Service Advisory W-116

Model: Z16, Z180, Z200, Z180L
Date: September 16, 1998 (REVISED 10/12/98 - Destroy previous copy)
Subject: DECLUTCHING CABLE KIT 759-3874

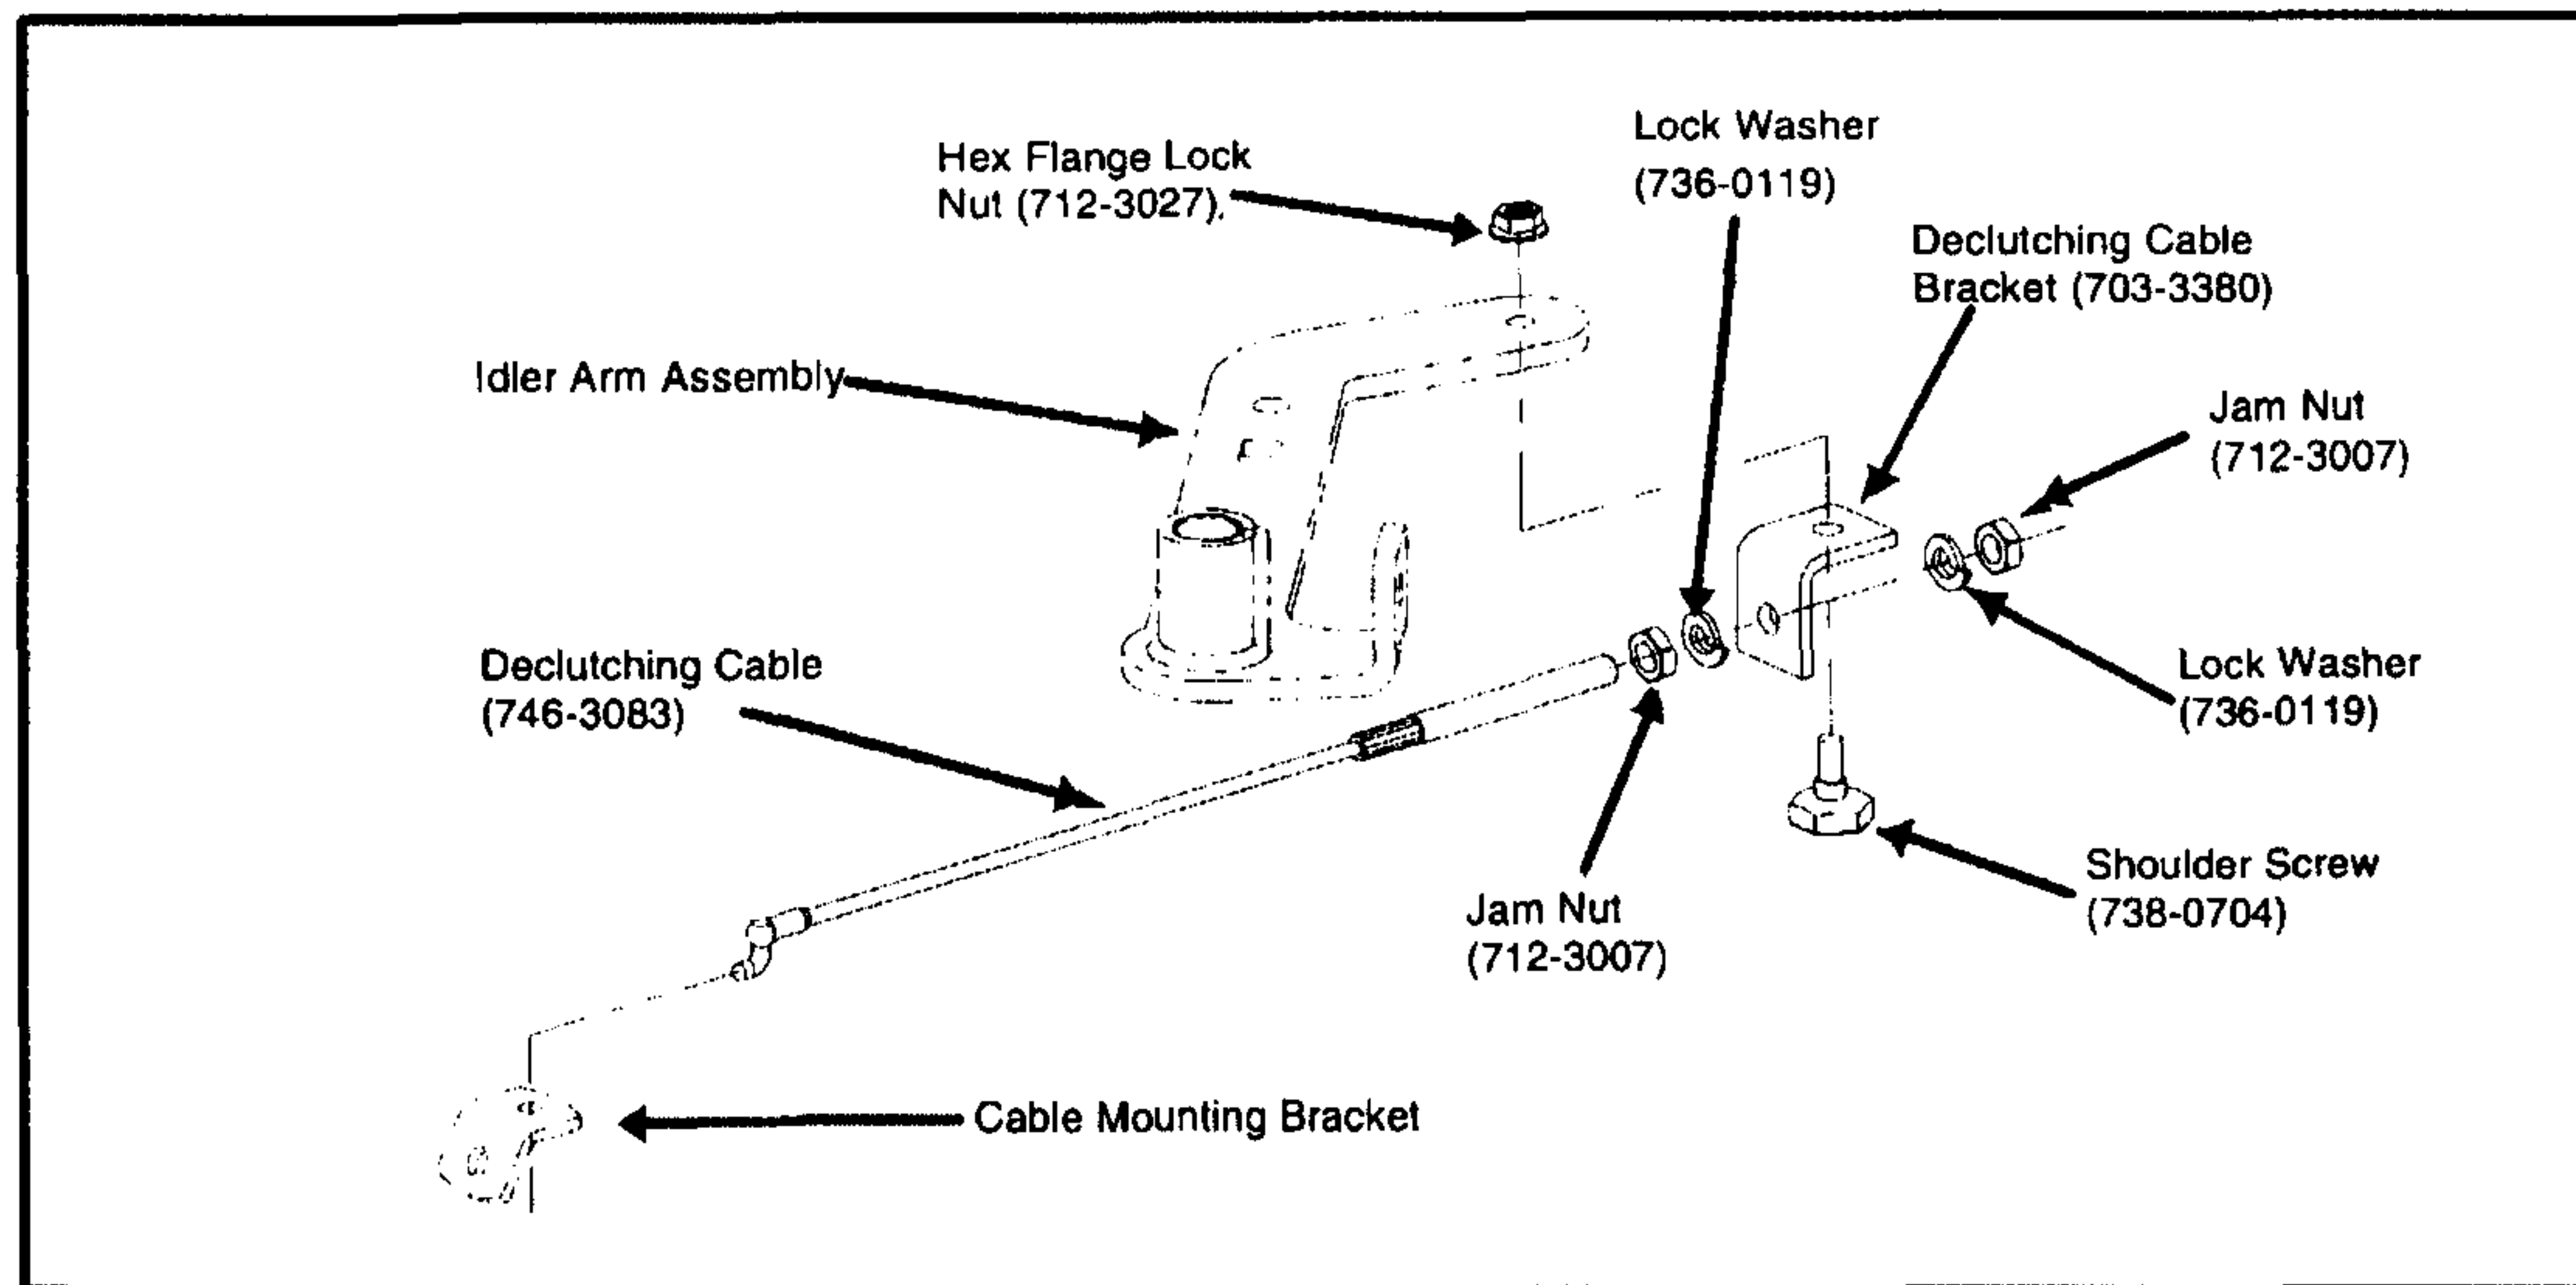
Some Z Series Mowers are experiencing traction problems resulting from the inability of the transmission drive belt to remain tight against the idler pulley. A product improvement has been made by adding a threaded end to the declutching cable and passing this through a bracket allowing the cable to be adjusted to compensate for belt stretching and wear. A product update kit has been developed with the necessary parts and instructions. Parts ordering and warranty information can be found below.

Use the illustration below for future reference.
